**RE: Response to NYSDEC DEIS and Mined Land Reclamation Application Comments
DEC ID No. 8-4424-00006/00001 / MLR # 80244
It's Greener Now, Inc. - Padua Gravel Pit Expansion
Town of Dix, Schuyler County, New York**

NYSDEC draft Environmental Impact Statement (DEIS) Comments – July 19, 2019

MINE PLAN MAP
IT'S GREENER NOW, INC
 PADUCA RIDGE
 TOWN OF DEKALB
 SCHULER CO., NY

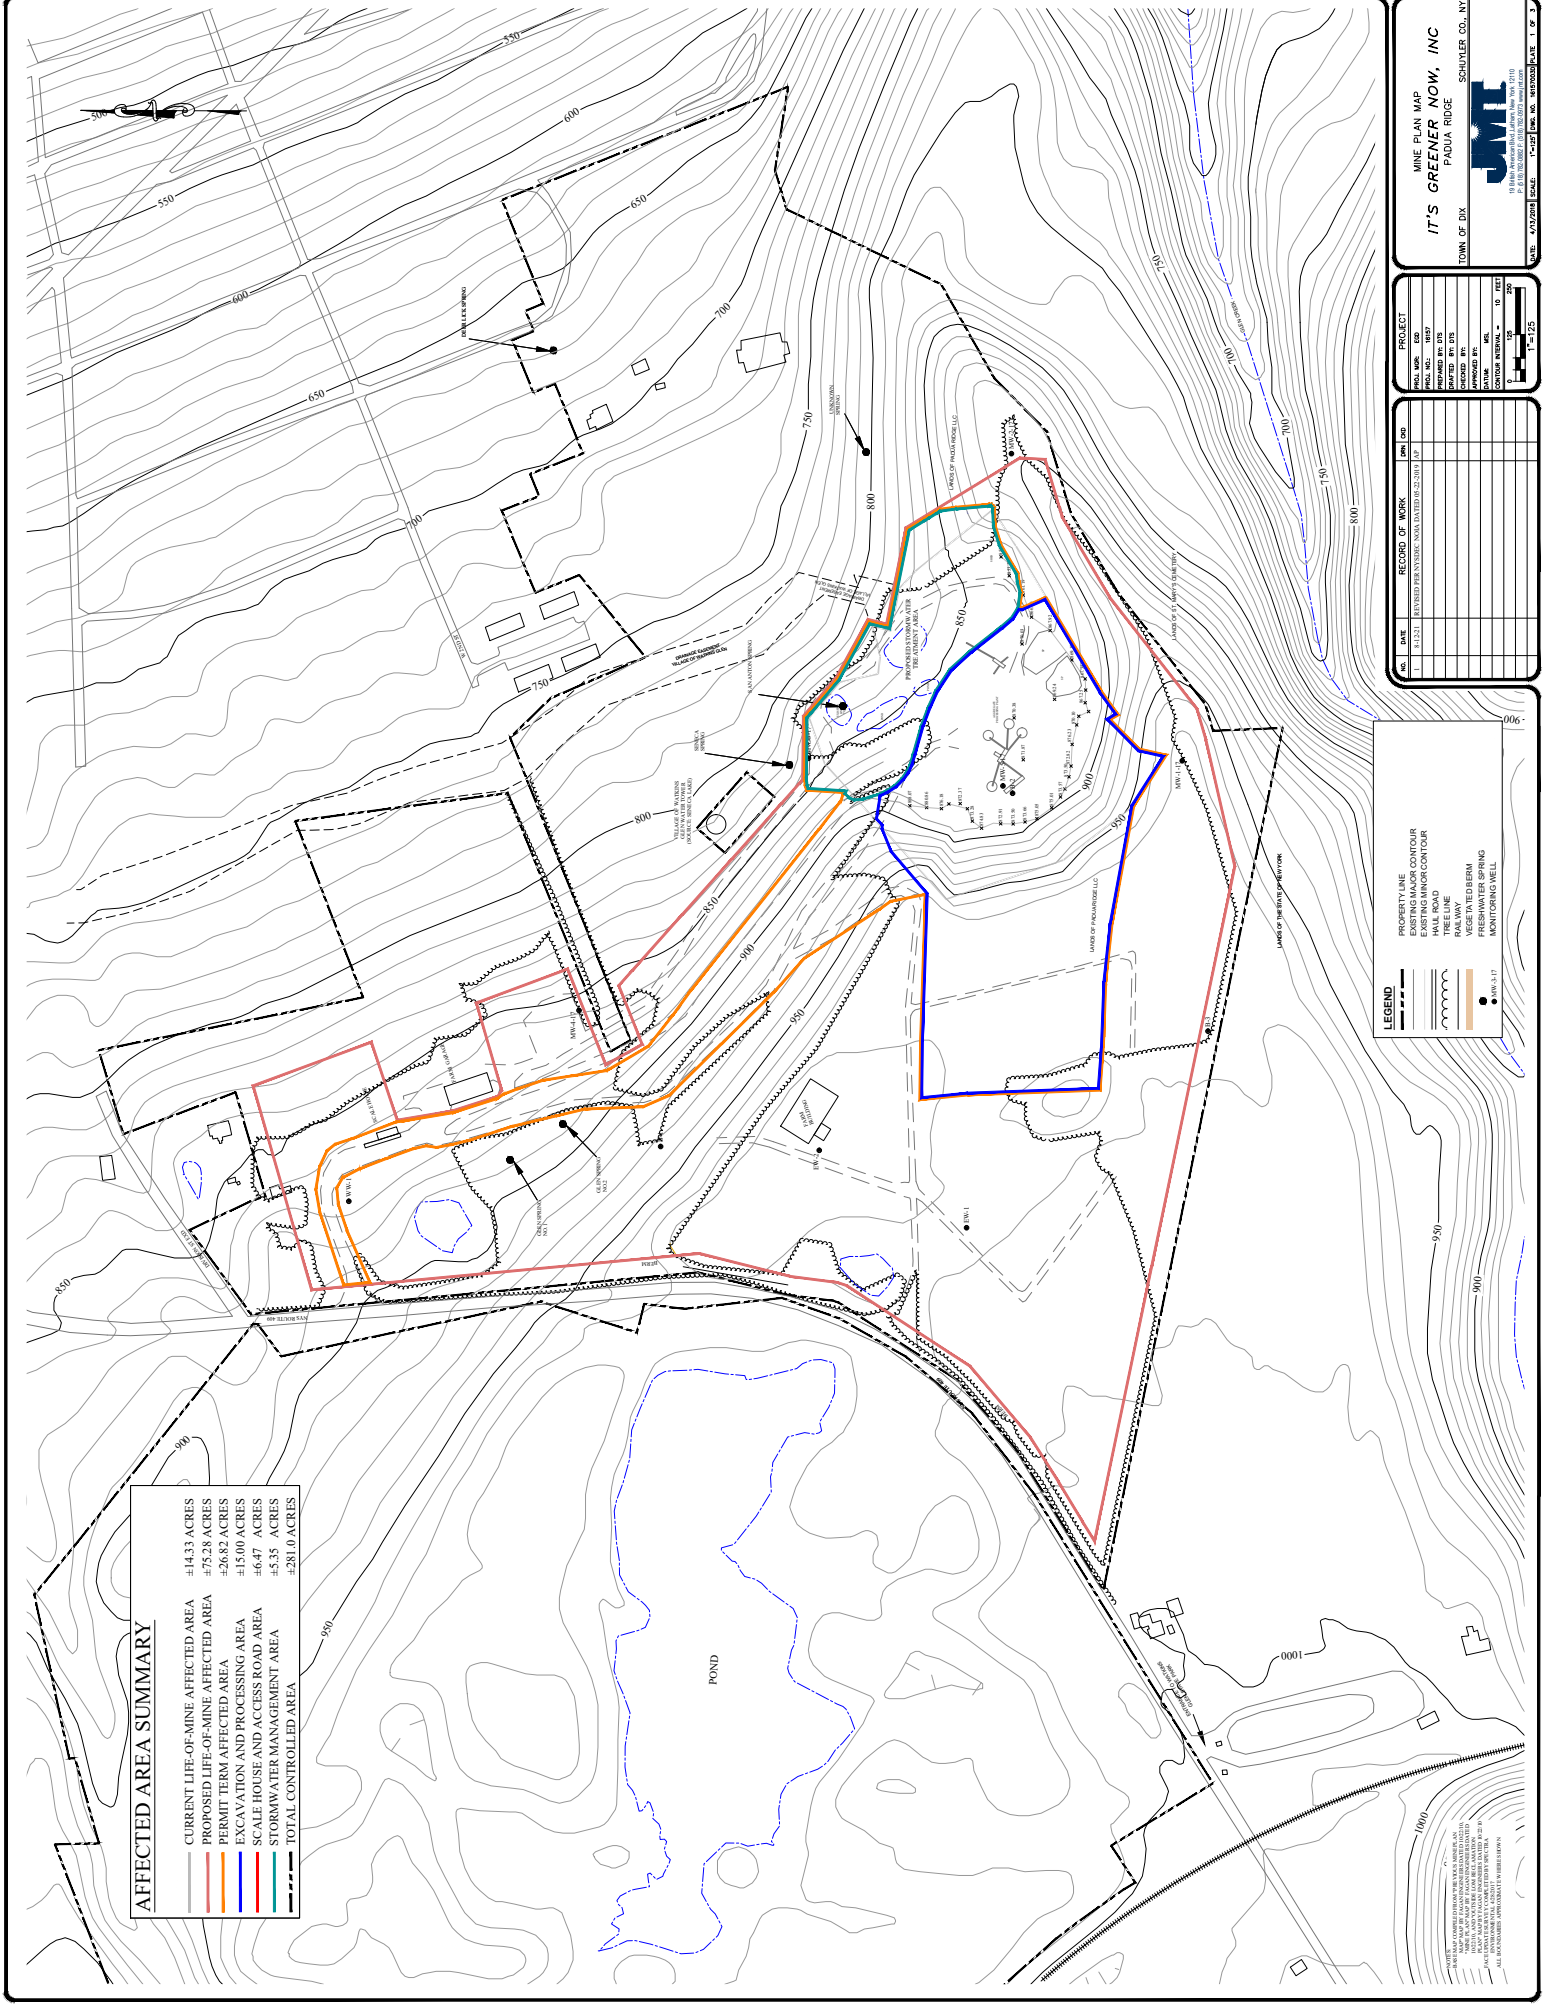
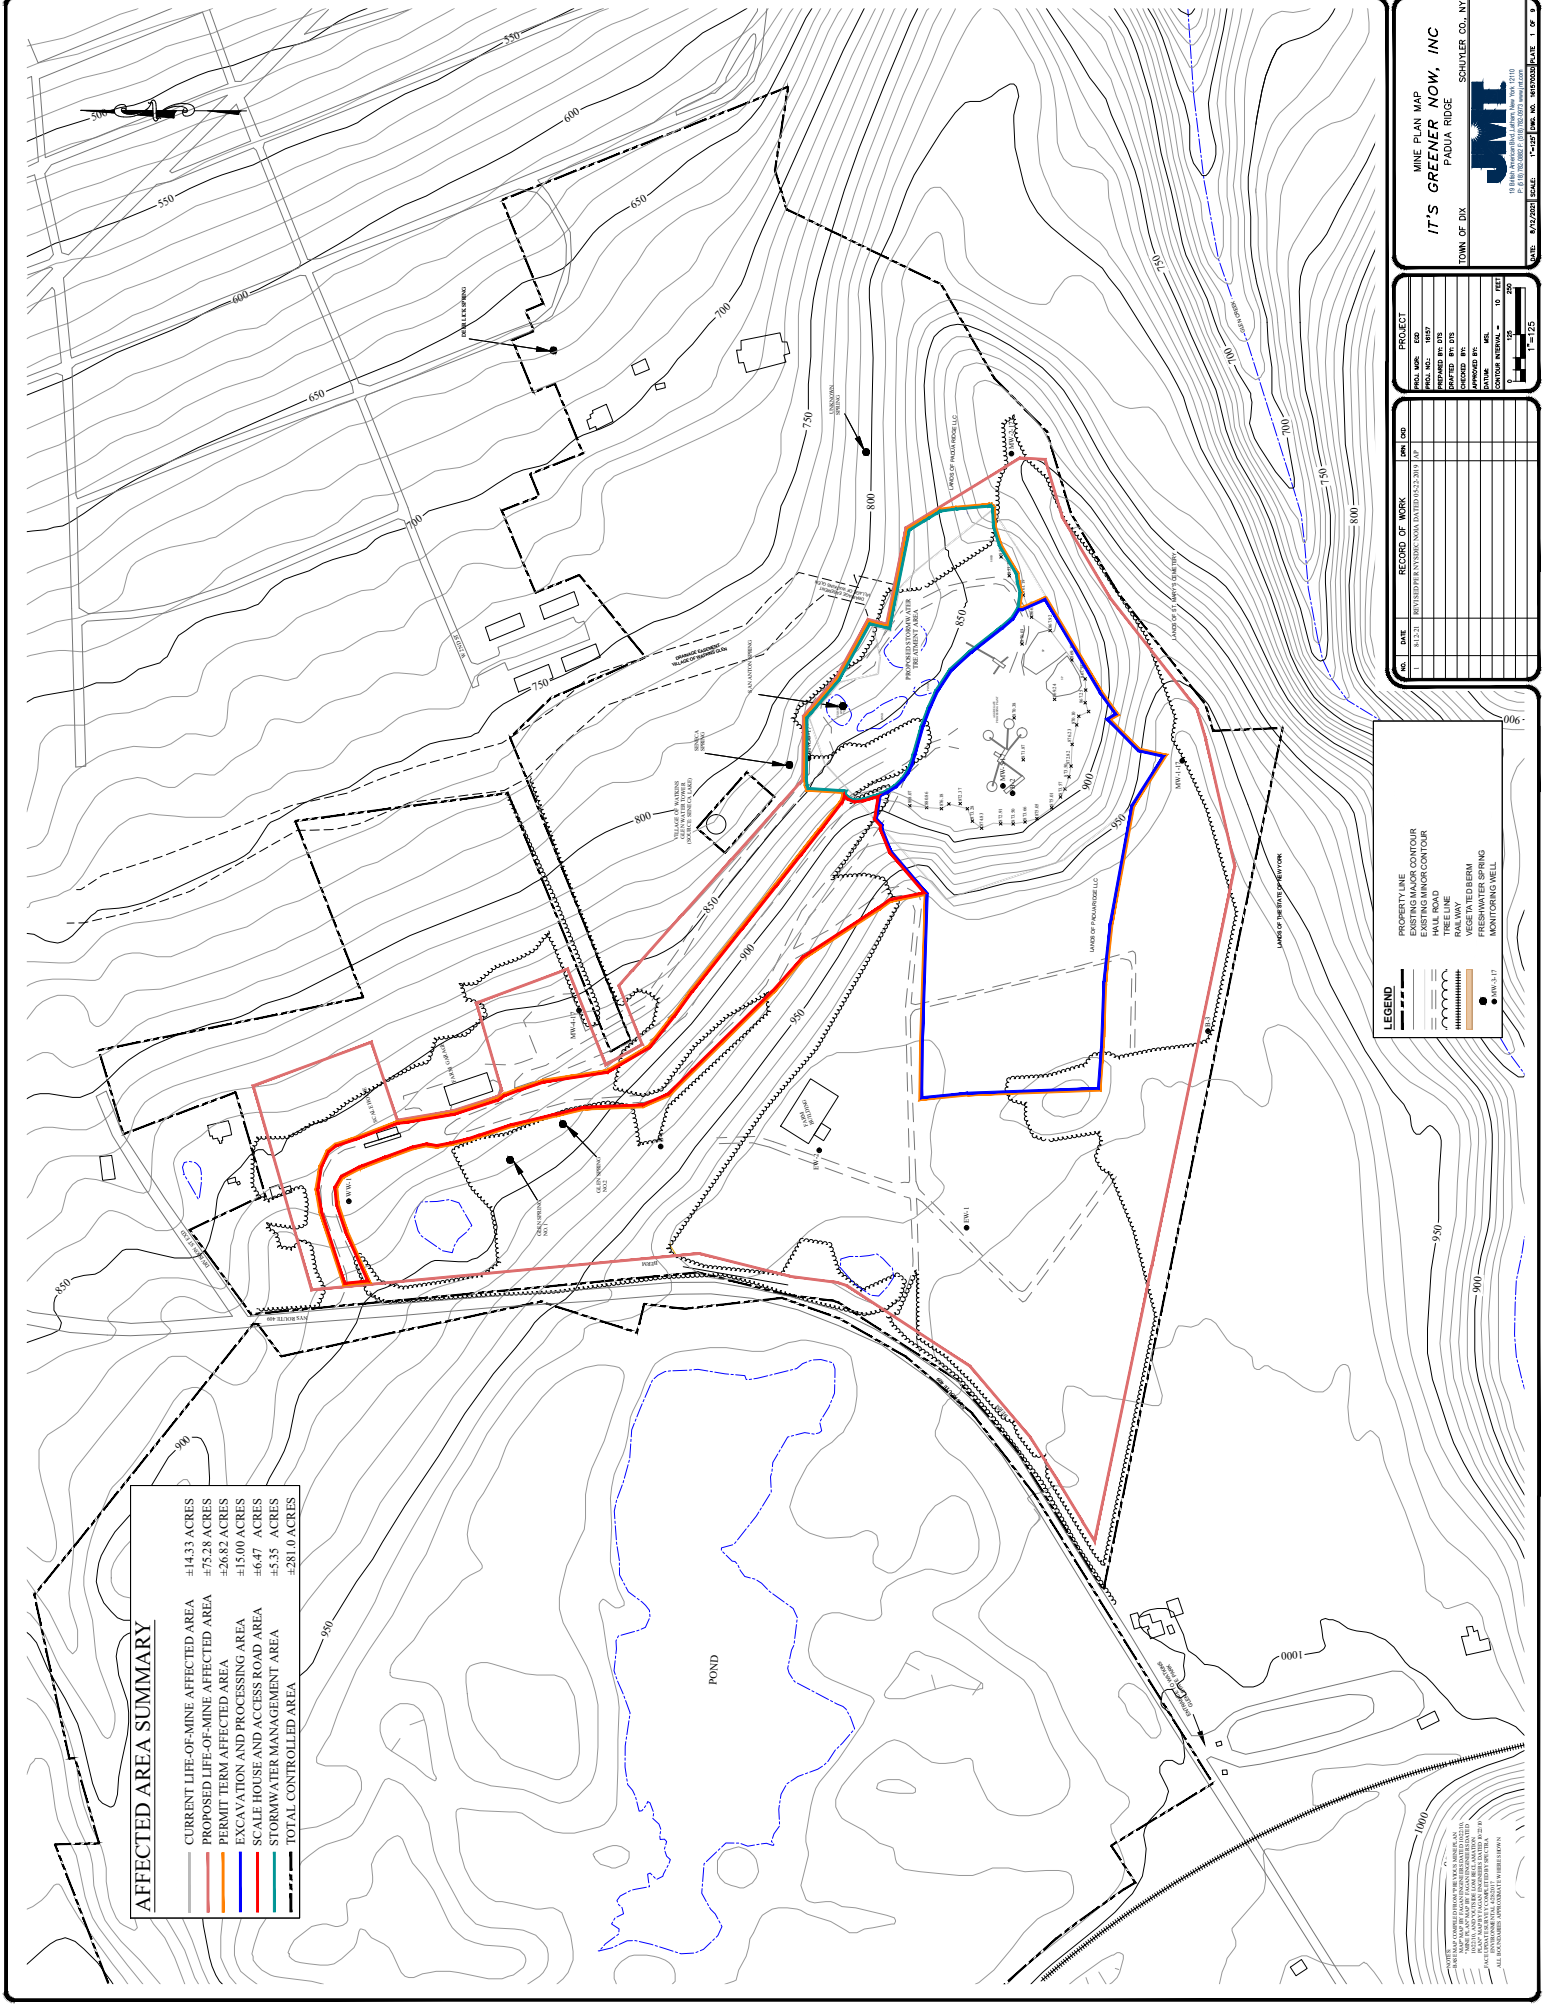
- 3) *The Mining Plan Map in the MLUP and DEIS show the western berms are located outside of the Life of Mine. These berms should be located within the Life of Mine boundary, or the boundary adjusted to encompass the berms. If the Life of Mine is expanded to include these berms, appropriate acreage adjustments must be made on the mining permit application form, EAF, maps, and narratives of the MLUP and DEIS.*

4) *Please revise the DEIS/MLUP Mining Plan Maps (plate 1 of 9, and Plate 1 of 3 respectively) to include the previously approved 14.33-acre LOM, and the proposed permit term affected area, including the anticipated 15-acre excavation area.*

Response: The majority of the western berm referenced in this comment is currently in-place along NYS Route 409 (Sheet 1 of the MLUP), having been previously constructed in support of ongoing agricultural activities, and pre-dates IGN’s proposed LOM expansion. Therefore, IGN believes that this section of berm should not be included in the expanded LOM. However, the newly proposed southernmost leg of the berm will be located within the proposed LOM, per the previously submitted Mine Plan Map.

Response: The DEIS and MLUP Mining Plan Maps have been updated to include the previously approved 14.33-acre LOM per request. Both drawings (Plate 1 of 9 and Plate 1 of 3) are included in Attachment F.

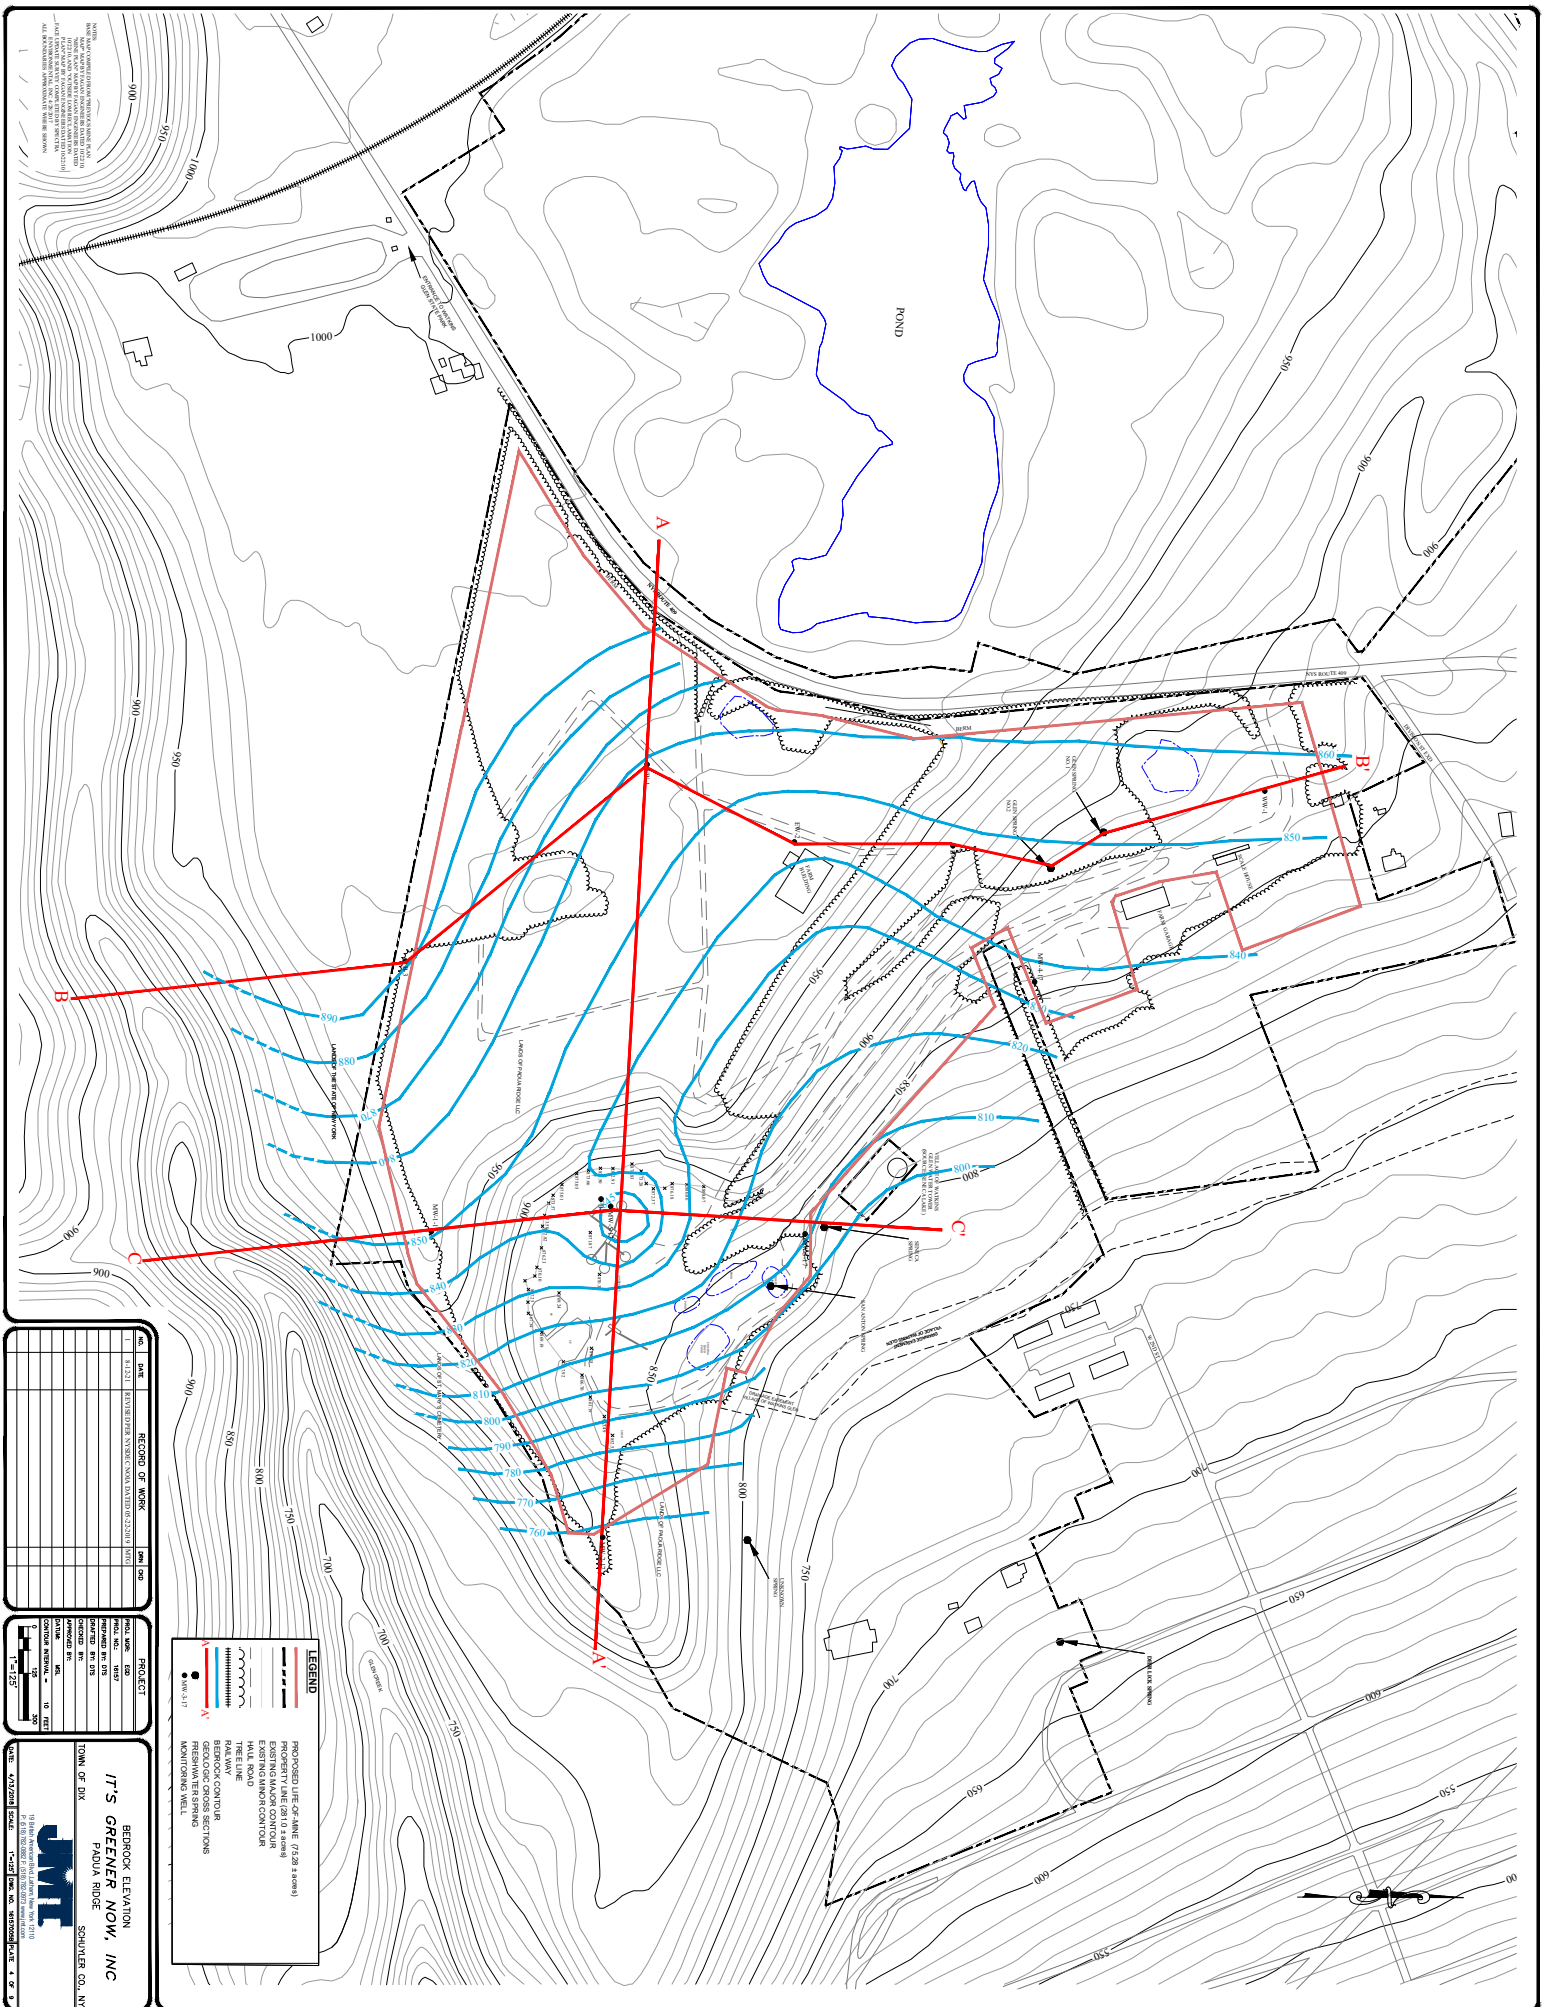
10) *Sheet 4: Bedrock Elevation - It appears that bedrock elevation interpretations on the Bedrock Elevation Map, Plate 4 of 9, were made based on data from wells B1, B3, EW1, and EW2. Please provide data/information on these wells.*

- a. *MW 2-17 does not indicate that bedrock was encountered at its final depth of 134' BGS, yet it appears that it was used to interpret the bedrock elevation on the Bedrock Elevation Map, Plate 4 of 9. Please clarify.*
- b. *The log for MW 3-17 shows a Depth/Datum of 124' BGS, yet it appears that the boring was terminated at 32'. Please clarify.*
- c. *Any historic or continued (2018-2019) ground water monitoring data should be provided. Was the seasonal high groundwater elevation determined solely by the 2017 data when establishing the final reclamation contours and separation with the water table?*

6) *The location of MW-2-17 was left off the Bedrock Elevation Map (Plate 4 of 9). Please add the location to the map.*

Response: A complete catalog of geologic logs, which includes monitoring wells B1, B3, EW1, and EW2 are included in Attachment D. Please refer to Attachment D for further details.

Response: MW-2-17 has been added to the Bedrock Elevation Map (Plate 4 of 9) and is included in Attachment F.
